SUBJECT: Project 35993.1.1 (U-4700) Caldwell, Catawba, and Burke Counties
F. A. Project NHF-321(18)
Proposed US 321 Widening from US 70 in Hickory to Southwest Boulevard in Lenoir

**Post-Public Meeting
Meeting Summary**

Alex Lee Boulevard

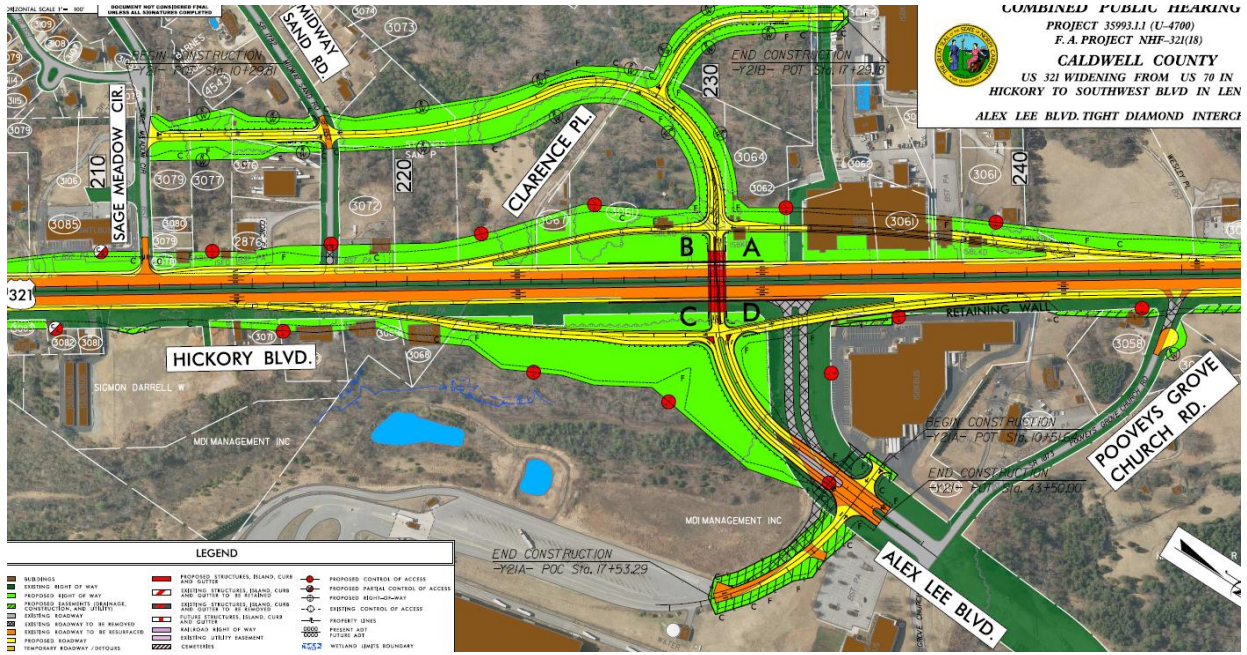
4. **Comment:** I'm concerned properties and businesses near the Alex Lee Boulevard interchange will be negatively impacted and would be better off with the interchange at Walmart.

Response: The proposed interchange at Alex Lee Boulevard impacts fewer residences and businesses than would an interchange at Walmart.
